**TOWN OF WINTER PARK
PLANNING COMMISSION
Tuesday, October 14, 2025 8:00 AM**

MEMO

TO Planning Commission
FROM Brian P. Kelly, Senior Planner
THROUGH James Shockey, AICP, Community Development Director
DATE October 14, 2025
RE Minor Site Plan – 238 Beaver Lodge Rd – Roam Filing 1 (PLN25-078)

PLOT PLAN

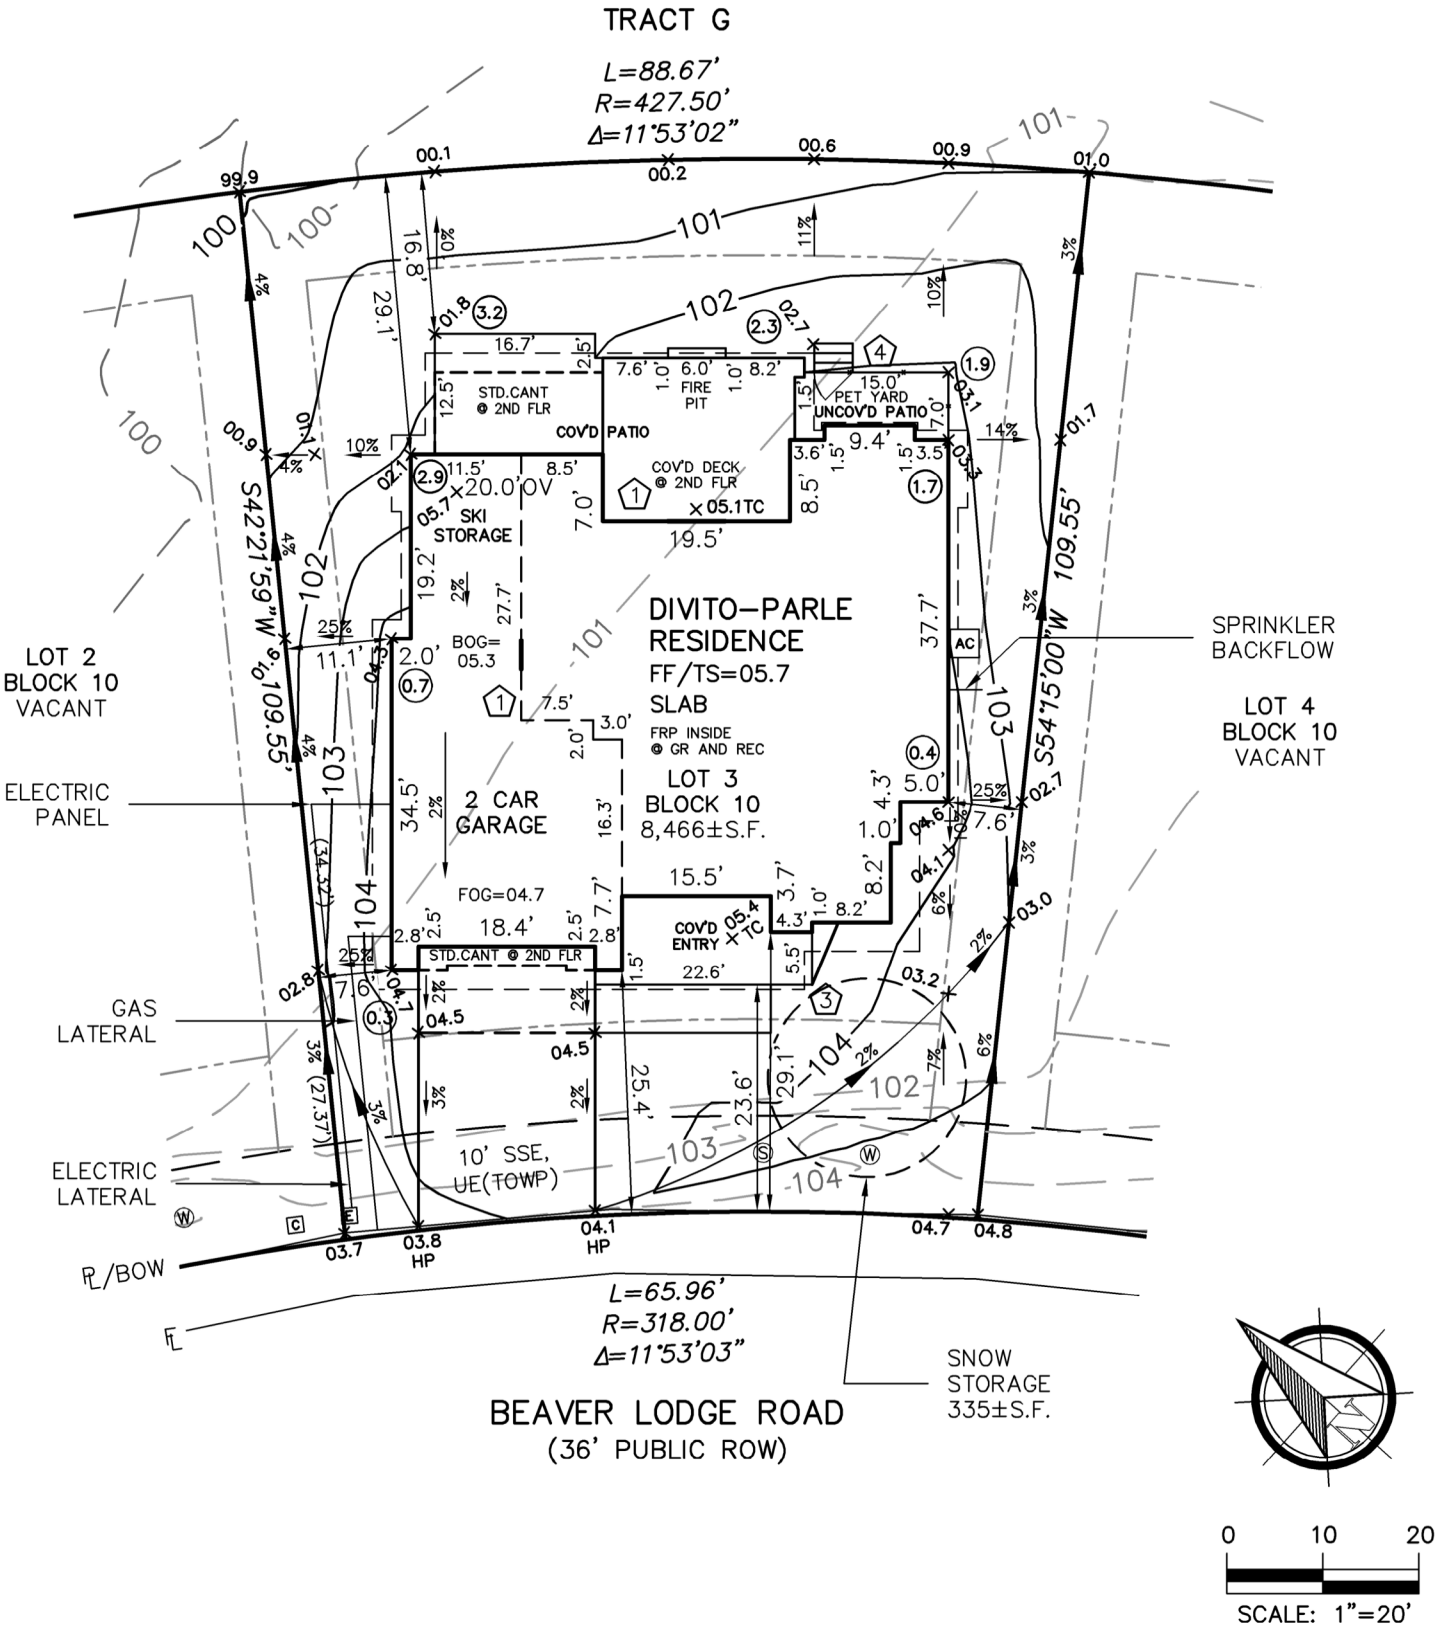
Unsatisfactory. UDC § 3-H-5 requires that a minimum of 25% of all driving surfaces, including gravel shoulders, parking areas, and pedestrian walkway areas have designated snow storage. The site plan demonstrates the following, indicating more than enough snow storage area is available.

However, the site plan shows an area of snow storage approximately 85 SF encroaching within the utility and snow storage easement designated for ROW use. Additionally, the proposed snow storage area is located a significant distance from the primary drive and walkway to front door.

- **At building permit**, submit revised plans demonstrating the snow storage area of at least 168 SF is within practical removal distance from hardscape surfaces and not encroaching within ROW snow storage easement area.

BEST MANAGEMENT PRACTICES PLAN

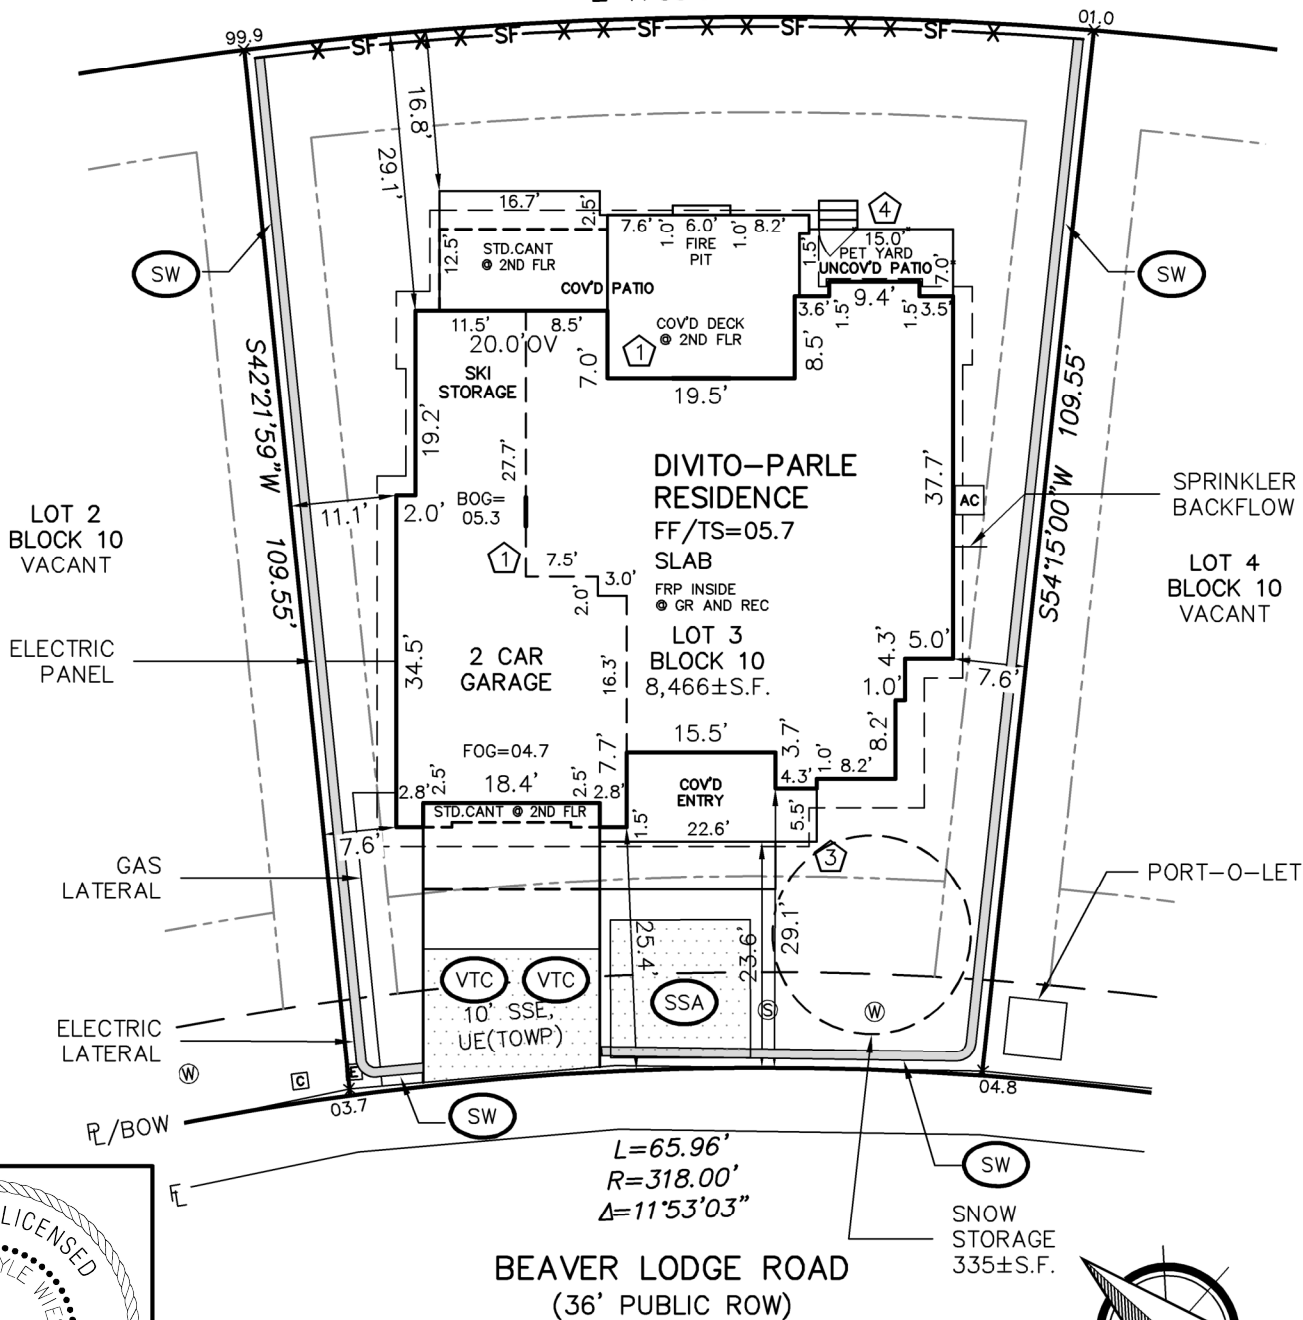
Unsatisfactory. Silt fence and straw wattles are one (1) FT inside property lines and delineate the limits of disturbance. Protection Notes were not shown on the Site Plan or Construction Plans to properly indicate to contractors the limits of activity.

- **At building permit,** submit a revised Site Plan, Construction Plan and Landscape Plan clearly showing the required Protection Notes:

- a. "No disturbance, grading, or removal of significant natural features and vegetation will occur beyond the limit of disturbance line, as shown on this plan"
- b. "The limit of disturbance line shall be delineated prior to construction with flags, roping, four (4) Ft tall orange construction fencing or other acceptable means."
